**FINAL
PRELIMINARY ASSESSMENT / SITE INSPECTION
REPORT
FOR
FORMER ACCURATE WEAPONRY AND PLATING SITE
CLEARWATER, PINELLAS COUNTY, FLORIDA**

Revision 1

APPENDIX E
RESPONSE TO COMMENTS LETTER REPORT

Subject: Response to Comments
Preliminary Assessment/Site Inspection Report
Former Accurate Weaponry and Plating Site
Clearwater, Pinellas County, Florida

1. Page 2-3, Section 2.0 – Figure 2-2:

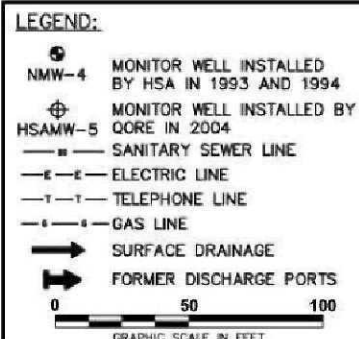
Comment: “Is better resolution possible (for figure 2-2)?”

Response: Yes, Figure 2-2 has been corrected and will be included in the Final PA/SI Report.
